CITY OF OLYMPIA
Olympia Design Review Board

DETAIL DESIGN REVIEW STAFF
REPORT

Project Name/Number:	Family Support Center of South Sound (FSCSS), Phase I, File 21-2734 & 21-4420
Applicant:	Ayla Mull, Johnson Braund, Inc.
Location:	3524 7 th Avenue SW
Project Description:	Construct a 4-story building with 62 affordable apartments, surface parking for 62 vehicles, long- and short-term bicycle parking, an extension of Fieldstone Avenue and open space for residents. This proposal is the first phase in a two-phase development. In addition, the applicant has submitted a Binding Site Plan to create two lots, one for each phase of development.
Design Review District:	The project site is not within a design review district; however, is subject to the Multifamily Residential design requirements (OMC 18.170).
Zoning District:	PO/RM - Professional Office/Residential Multifamily
Comprehensive Plan Designation:	PO/RM – Professional Office/Residential Multifamily
City Staff:	Lydia Moorehead, Associate Planner Phone: 360.570.3746, E-mail: lmoorehe@ci.olympia.wa.us

3D VIEW - FROM 7TH AVE - OUTDOOR AMENITY

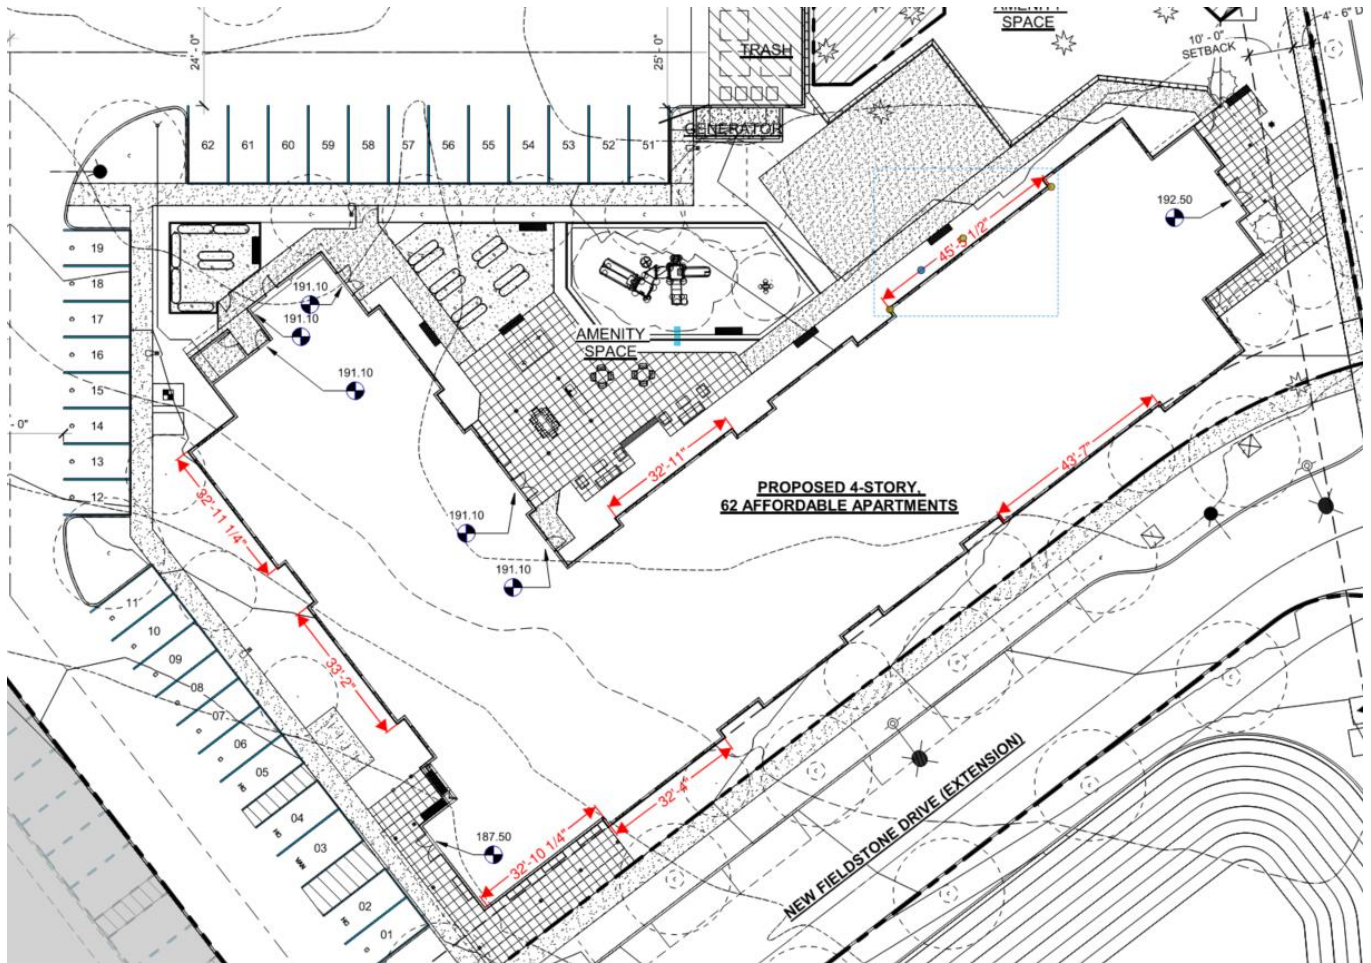
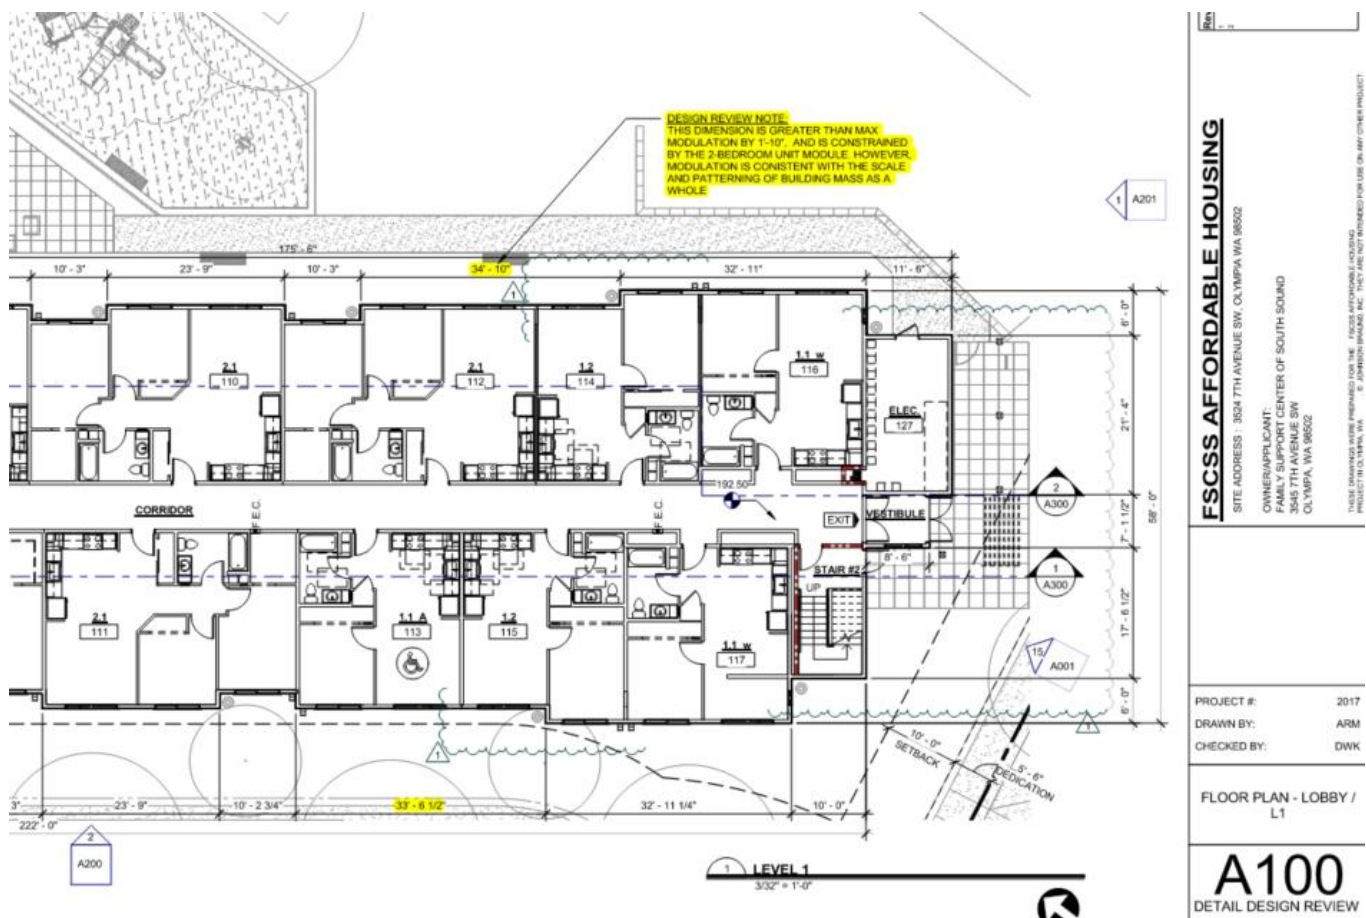
1. Building Modulation. At concept review the board accepted specific wall expanses of 33 feet, however two larger expanses were subject to the following condition:

Modify the larger wall lengths on the east and west facades to address lengths greater than 33' ft. in width. OMC 18.170.120.

The applicant has reduced the larger wall lengths (45' & 43') down to 33'- 6 ½" and 34'-10".

The applicant proposes variation in roof forms and variation (vertical & horizontal) in materials, colors, and window styles to reduce the appearance of larger building masses. The design guidelines specify methods to help break up building masses, some of which are employed. Those not used include porches, balconies and deeply recessed or protruding windows and/or light fixtures, or trellises to accentuate modulation intervals along the areas exceeding 30 feet in length.

The proposed wall lengths now more closely resemble what the board accepted at concept review for other wall lengths greater than 30 feet in length. Staff recommends approval.
